3. 630 Ocean Avenue

Planning and Urban Development Department

From: Matthew Grooms, Planner

JHA Assisted Living, INC and Cedars Nursing Care, INC are requesting a Level III site plan, conditional use, and site location of development amendment review for a proposed expansion of their campus located at 630 Ocean Avenue. The proposed development scheme, which includes demolition of an existing single-family building, reconfiguration of existing parking and construction of a new three-story building, is derived from recent trends in the long-term care model where residents are provided with private rooms as opposed to semi-private rooms. The proposed expansion represents a minimal increase in the number of residents, which are accommodated through additional on-site parking.

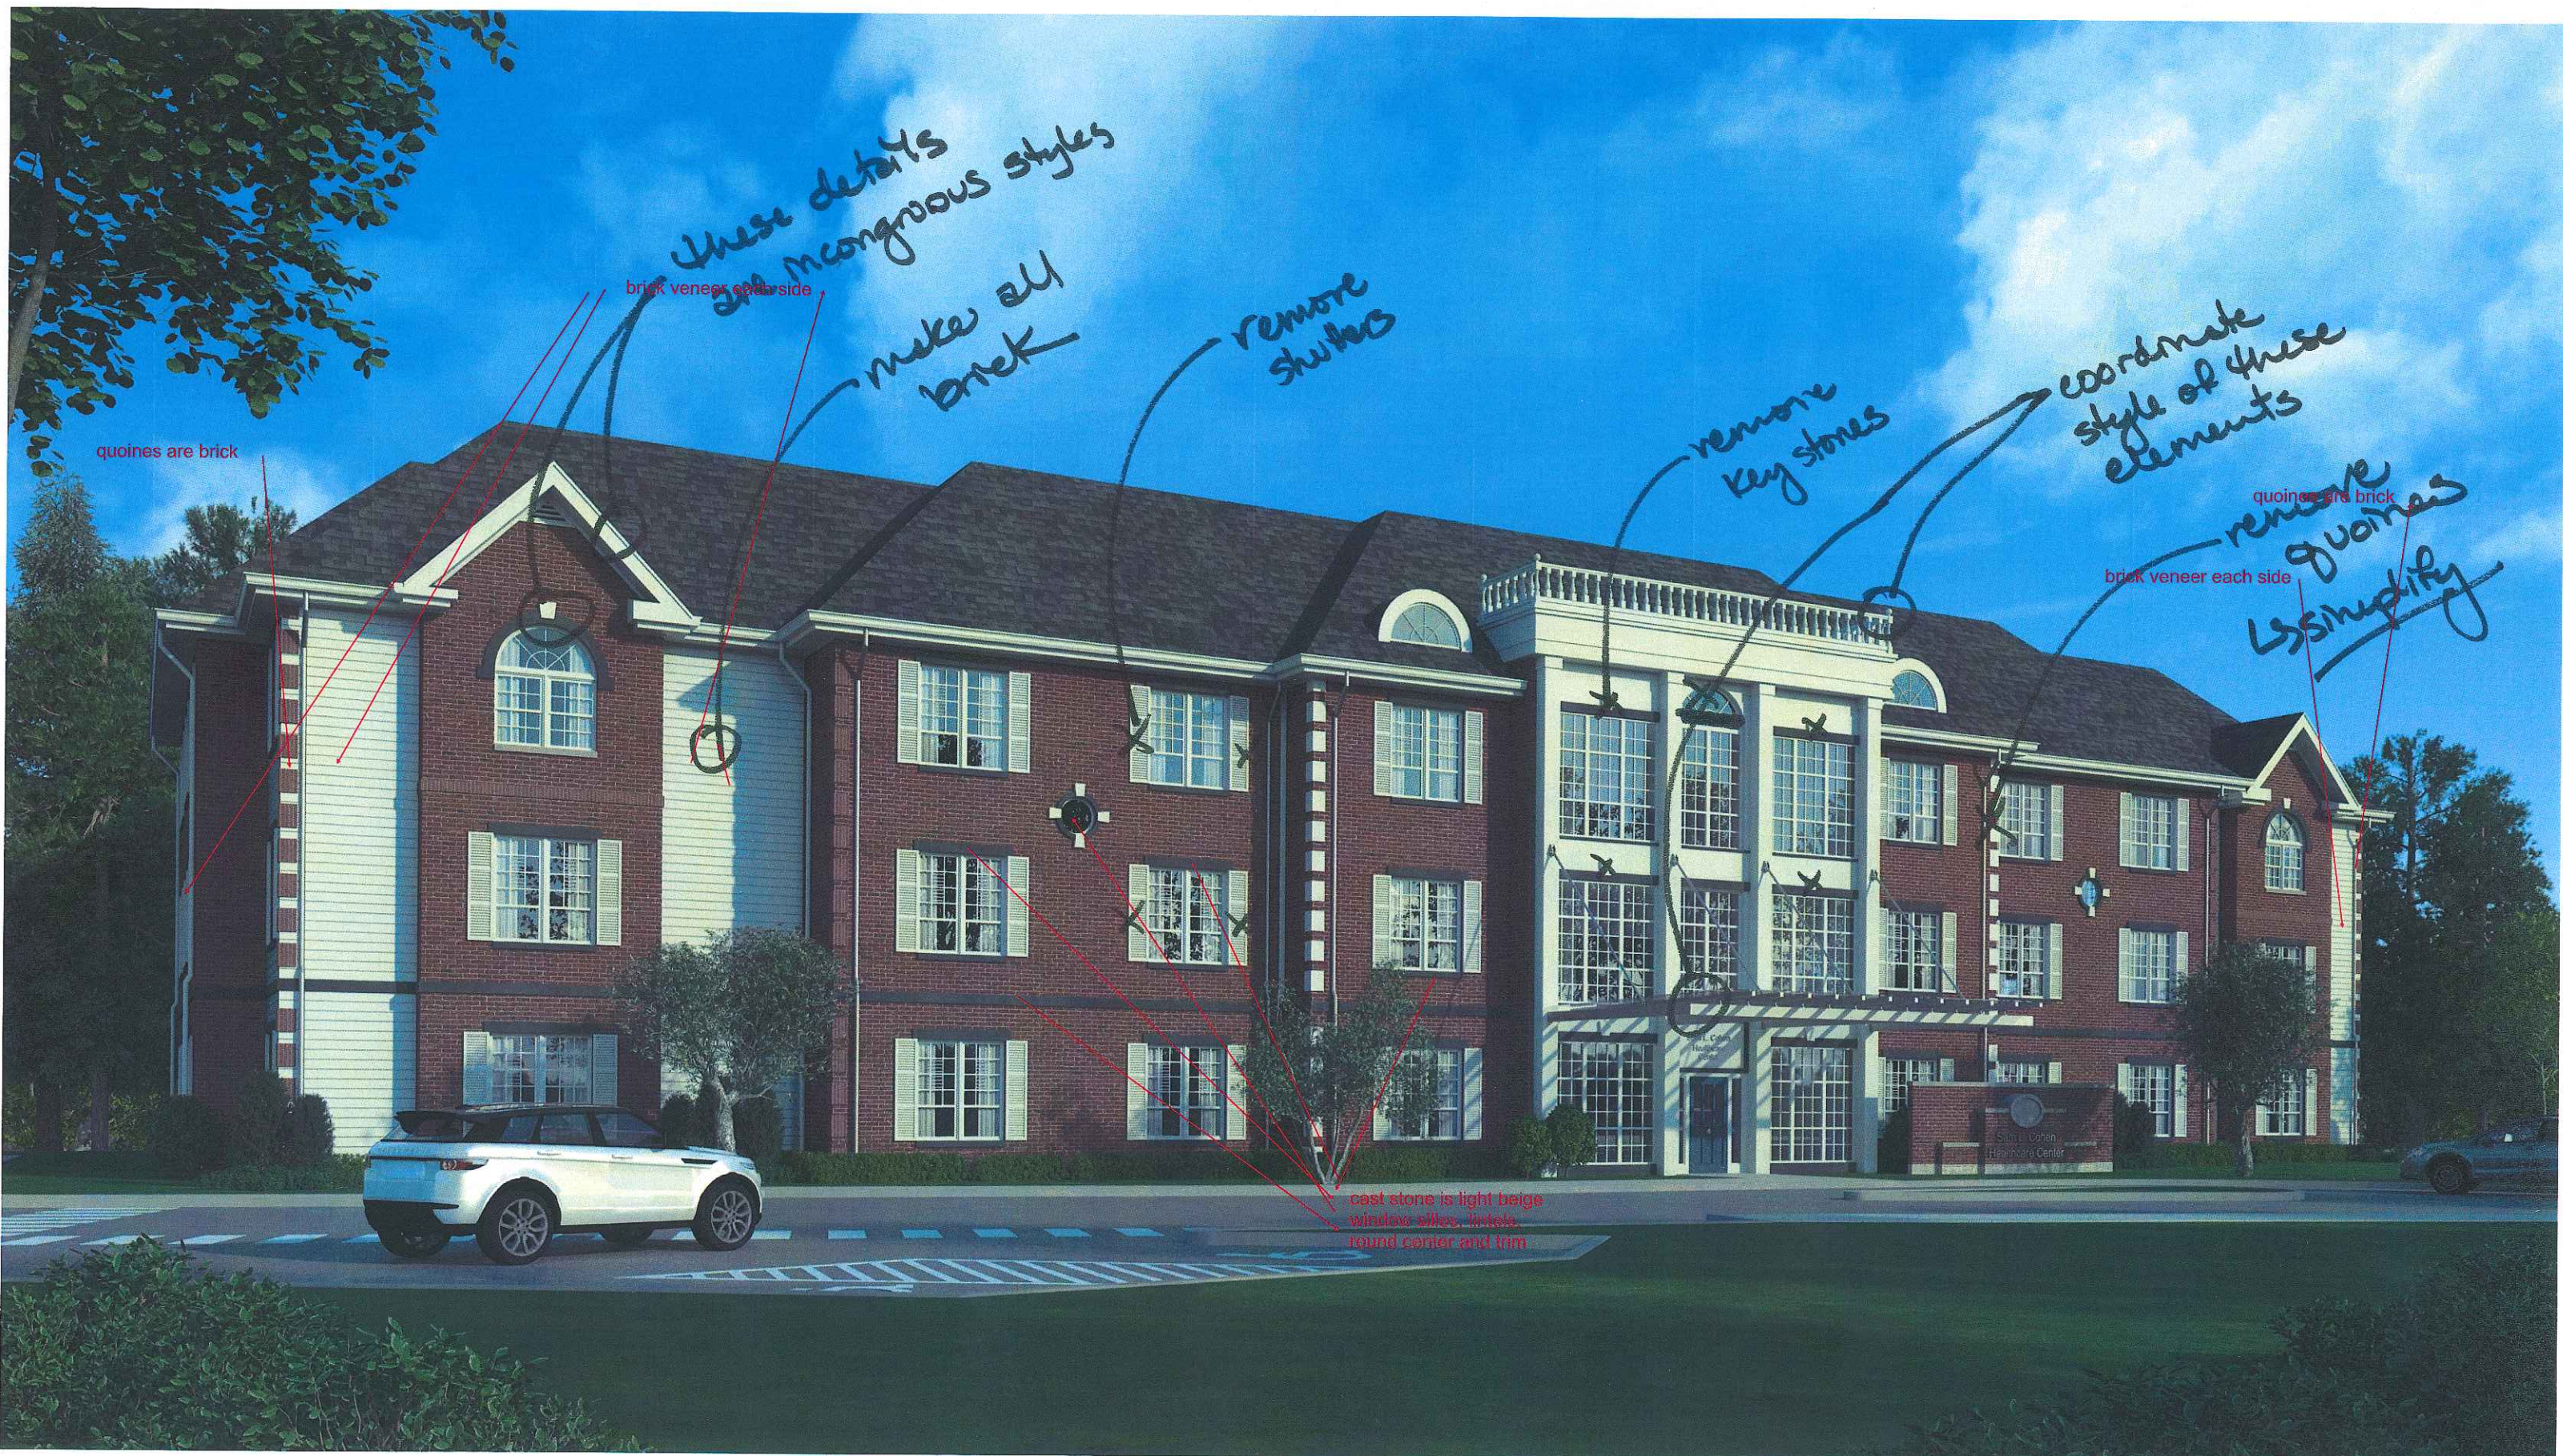
- Use all brick siding rather than introduce clapboard
- Remove extraneous details such as the quoins, “key stones,” fan windows
- Shutters are more appropriate for a small-scale residential building but not for this large-scale institutional building
- The entrance canopy is quite contemporary compared with the style of the building – staff suggest revising the central balustrade to reflect that contemporary design of the canopy.

Standard (2). Relationship to Street – Building placement is in relationship to the campus and put the side to the street. This is mostly to accommodate vehicle circulation and provide some buffer from the street for the occupants.

Standard (3). Open Space – Open spaces provided on property – landscaping surrounding building but no seating or similar occupiable open space within or immediately adjacent to this building. Building relationship to the street varies in this context – some buildings face the street, some are set back from the street, some turn the side to the street. Staff found this placement to be compatible with the street and the proposed use. Side/back facades have some massing variation and fenestration.

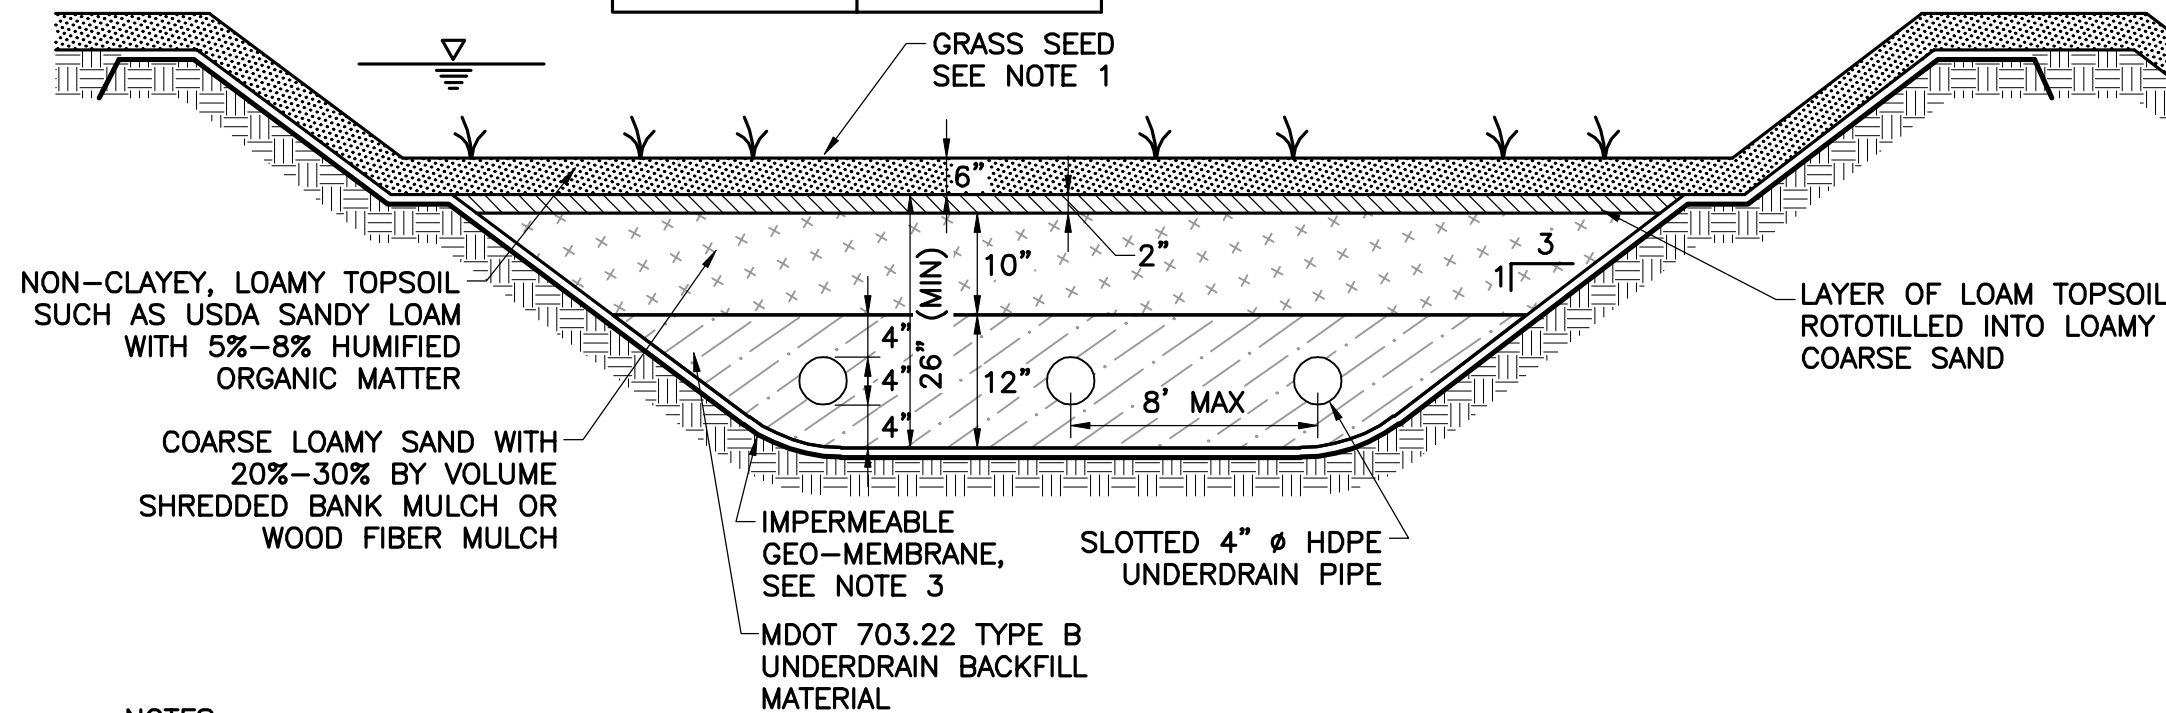
- *The soil filters do not have defined emergency overflow spillways. USF-A could overflow internal to the site; however, it appears that USF-B may overflow into Ocean Avenue. In the 25-year storm, the peak elevation calculated in the HydroCAD model indicates, that water levels may be higher than the soil filter berm and the elevation of the adjacent section of Ocean Avenue. The Applicant should address peak flow elevations, and provide for adequate emergency overflow to prevent the soil filter from draining into Ocean Avenue. (Note, this comment was not discussed at the January 30 meeting.)*
